SRF No. 0148483
 County Project No. 091101

**CSAH 112 – Phase 1
 Project Advisory Committee (PAC) Meeting
 June 17, 2015; 8:00 am – 10:30 am
 Orono City Hall
 MEETING RECORD**

Subject: CSAH 112 Phase 1 Final Design (Willow Drive to Wolf Pointe Trail)
Hennepin County Project No. 091101

9.5' OFFSET

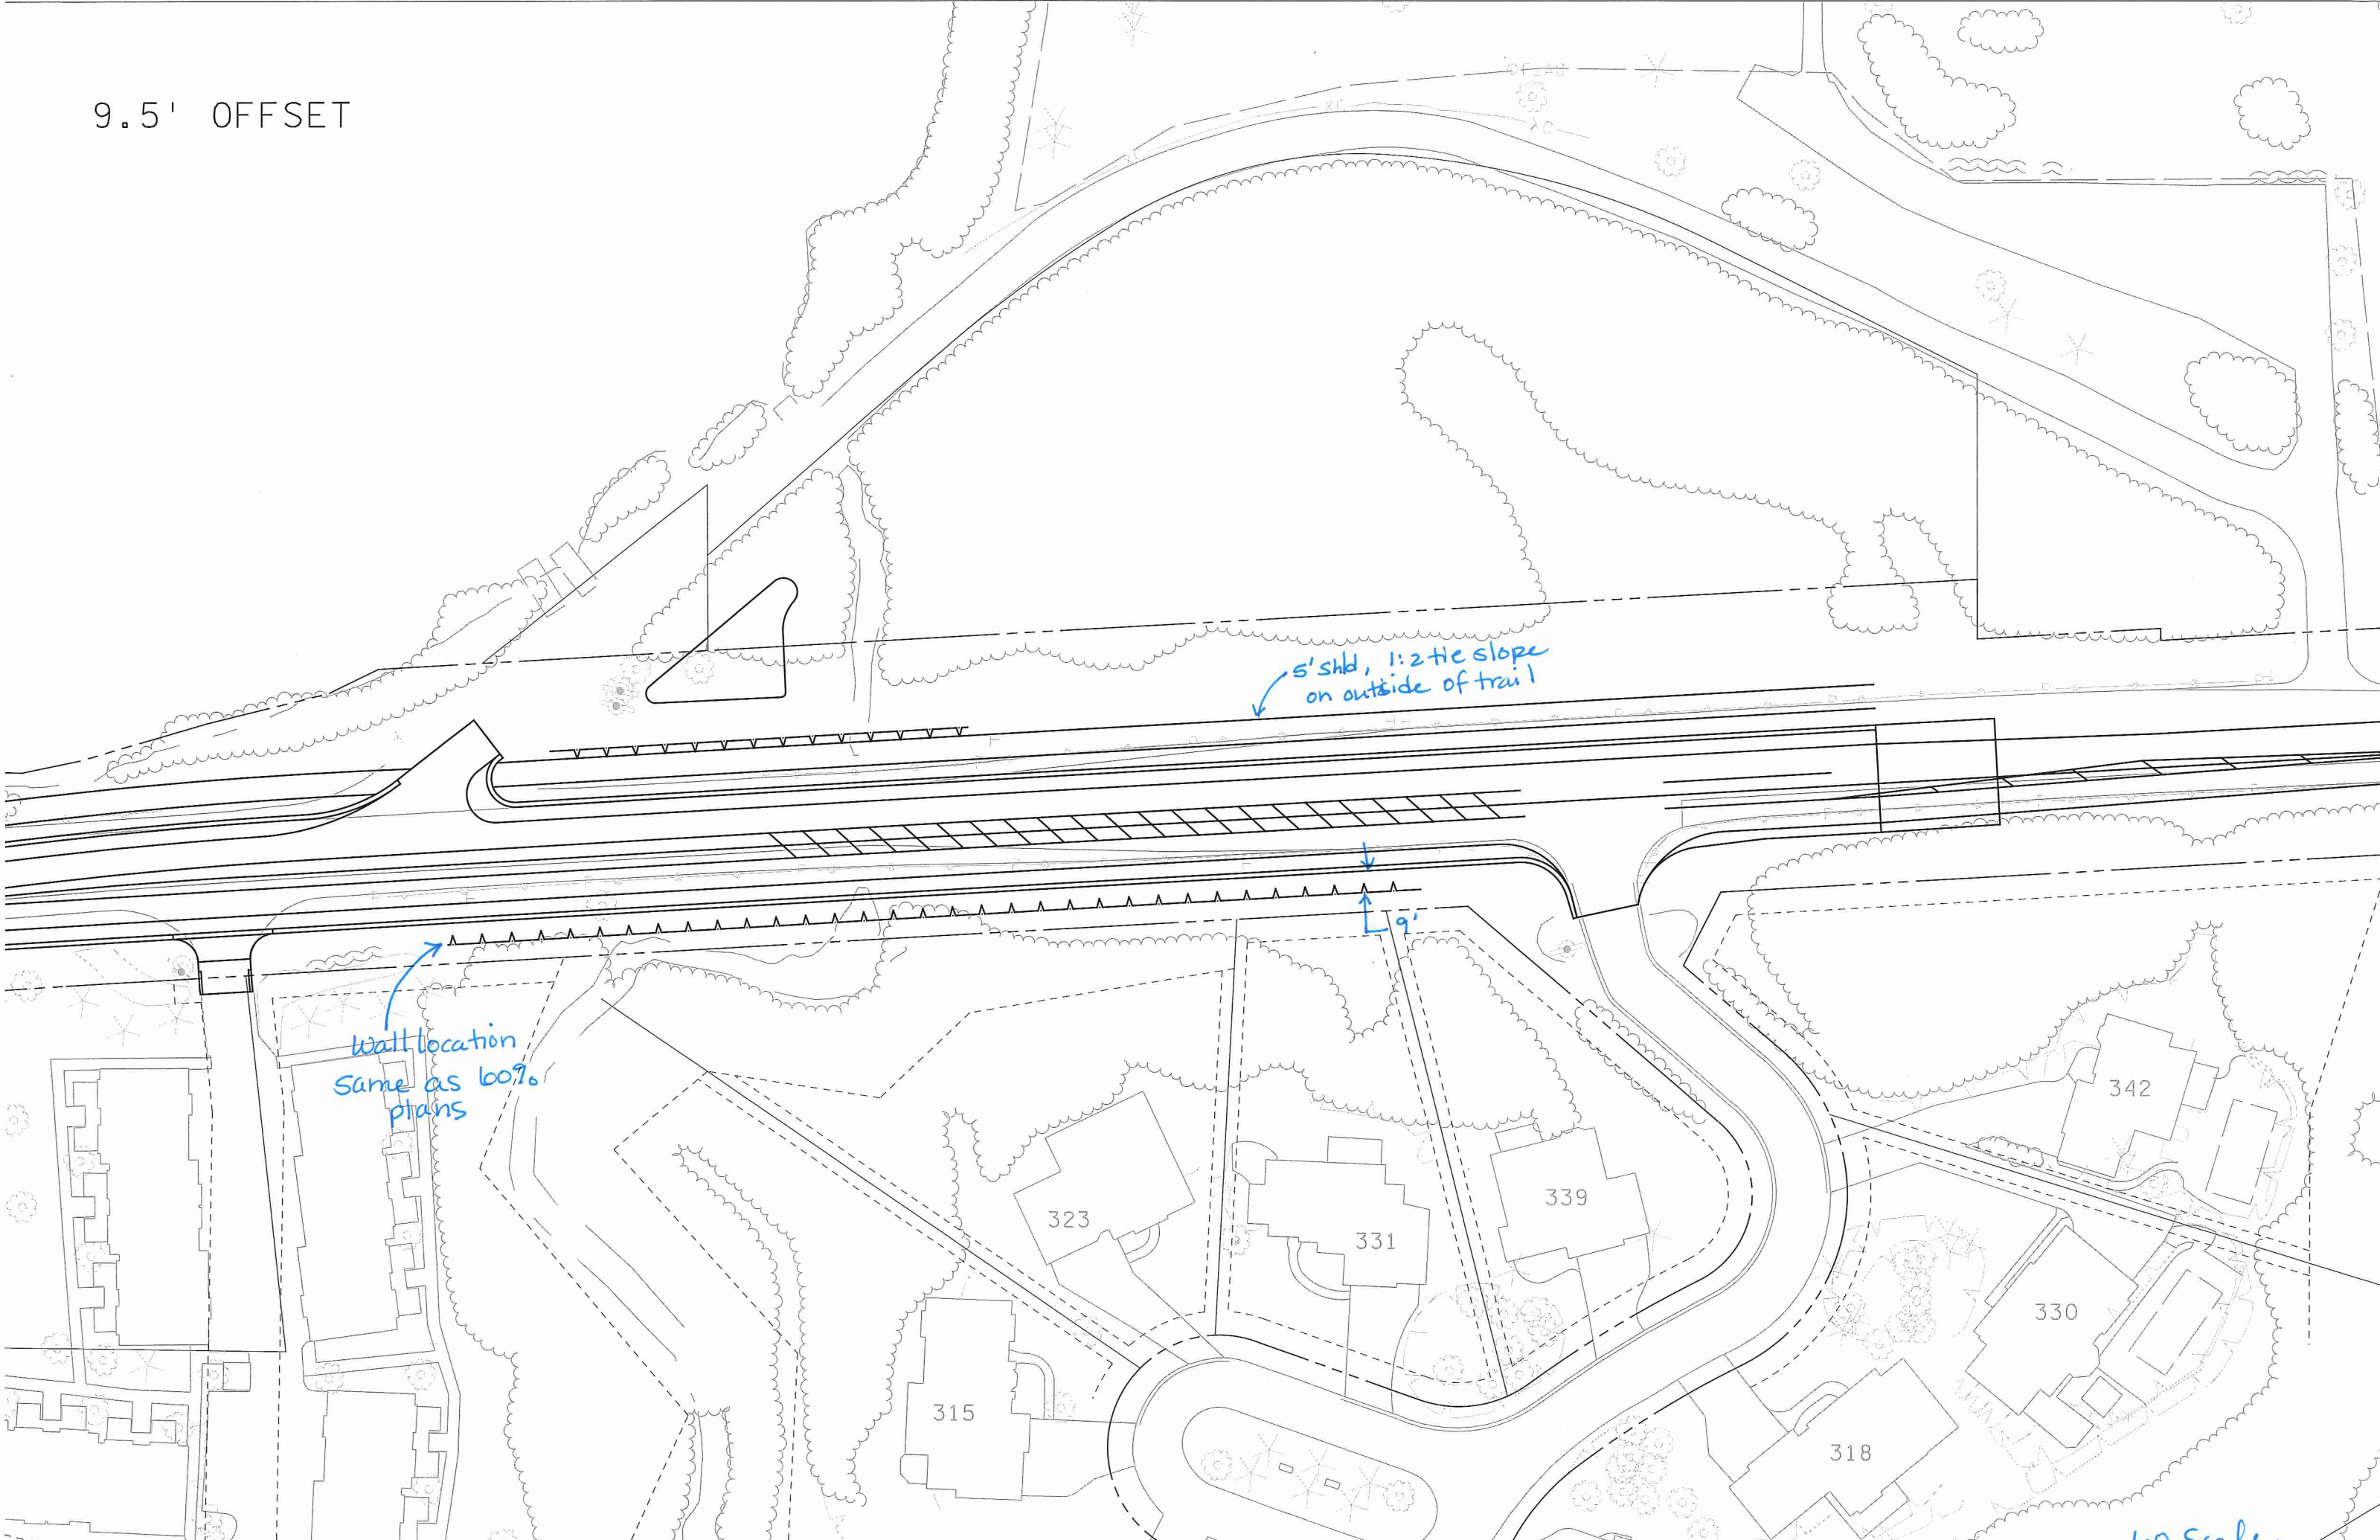
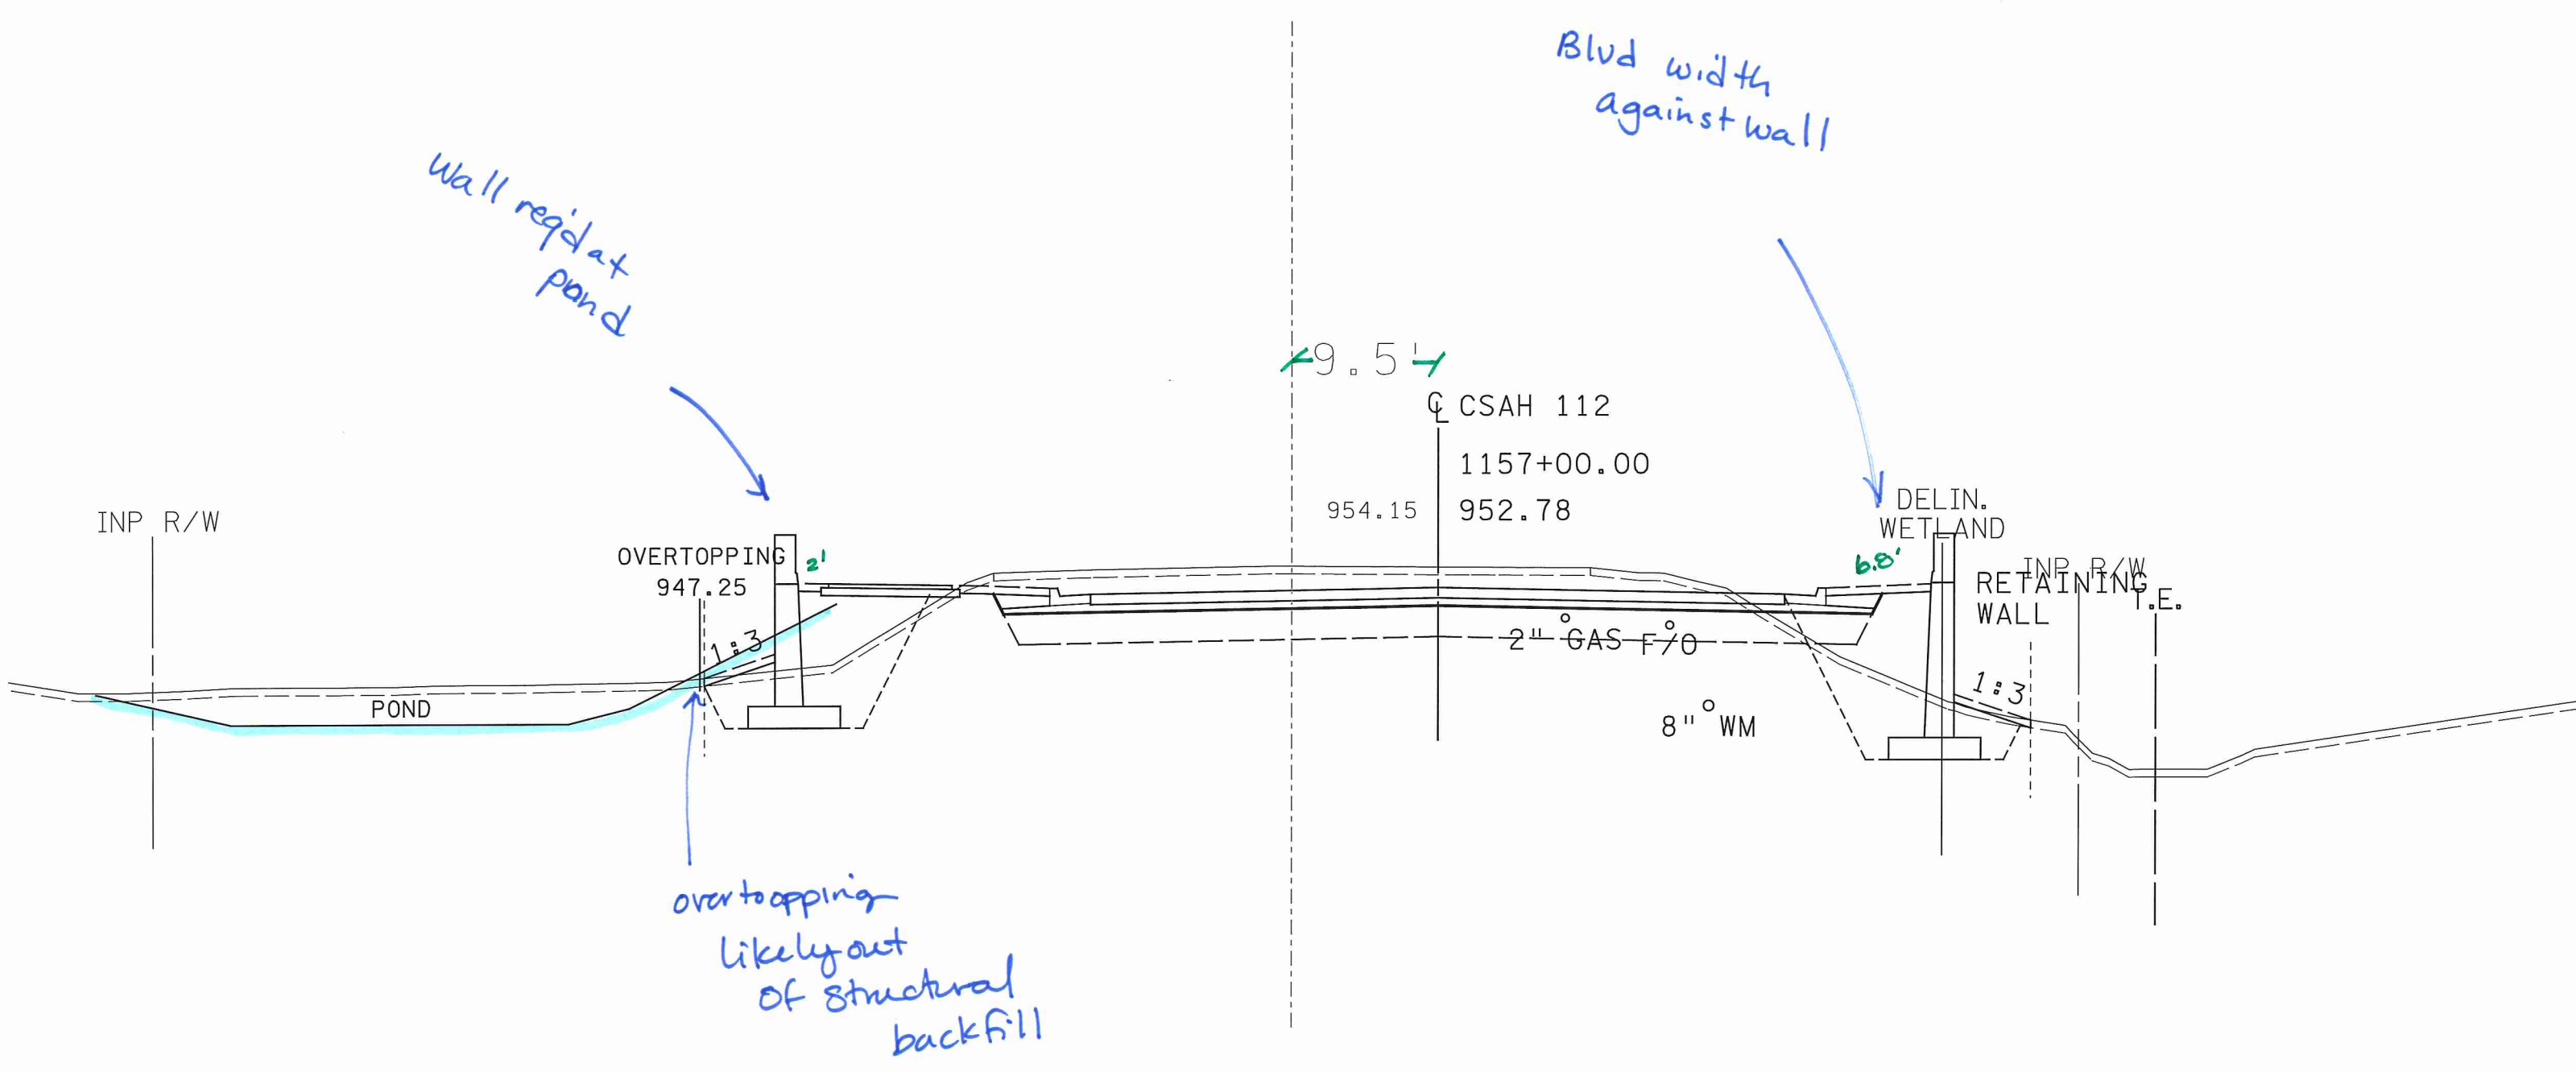
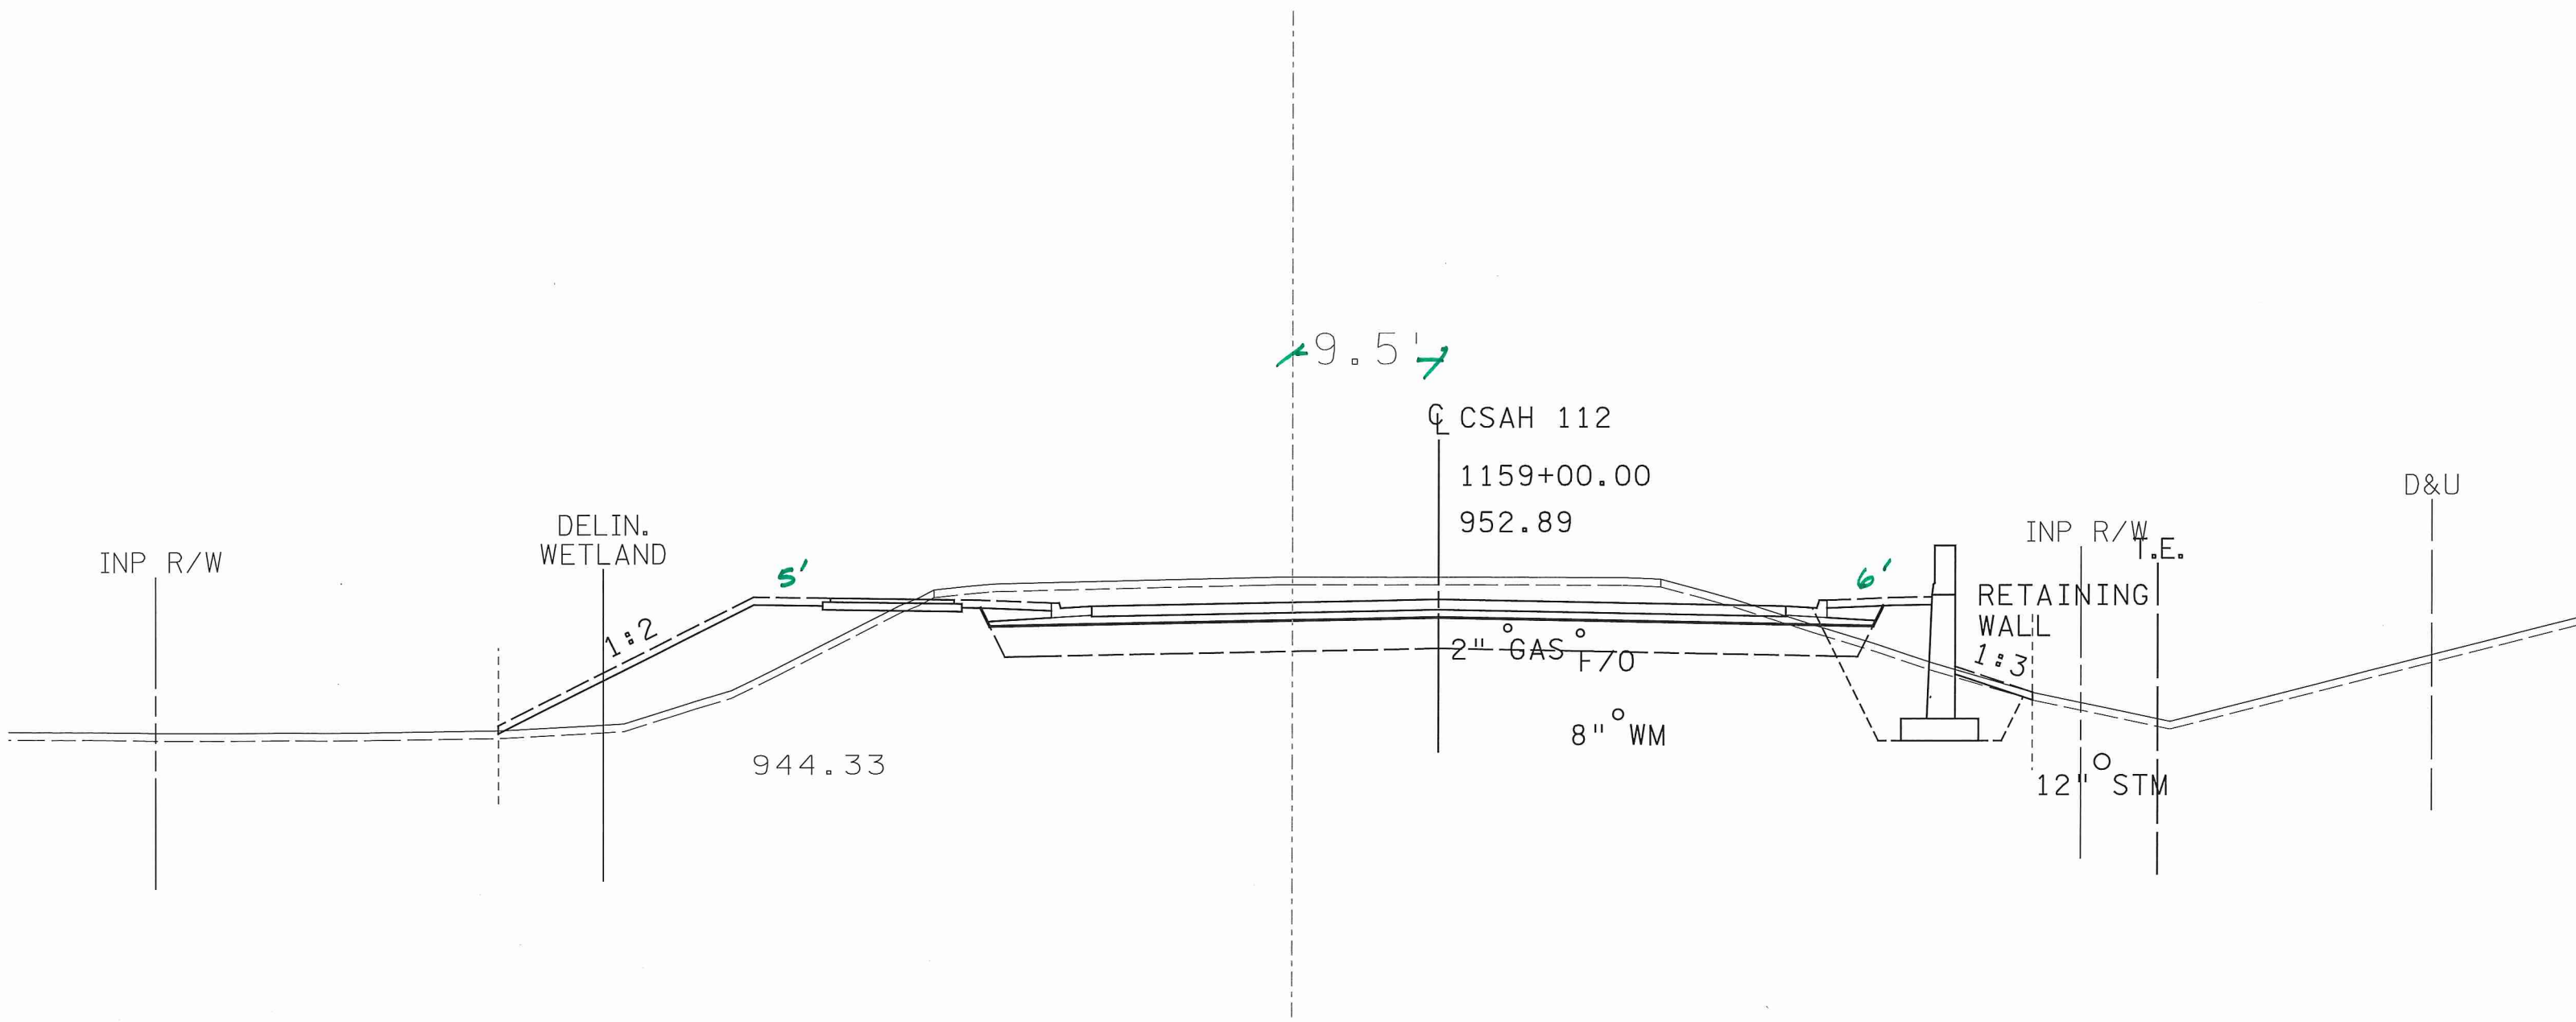
Nate described three (3) graphics (1 plan view & 2 cross sections) which illustrate the 9.5-foot centerline offset. He noted the basis for the 9.5-foot offset was developed by holding the current alignment of Wall G along the south side of CSAH 112 while providing an approximate 7-foot boulevard. He noted on the cross section that shifting the trail to the north side would require another retaining wall along the north side to minimize the construction impacts to both the adjacent wetlands and proposed stormwater treatment area.

5' shd, 1:2 Hc slope
on outside of trail

Wall location
same as 60%
plans
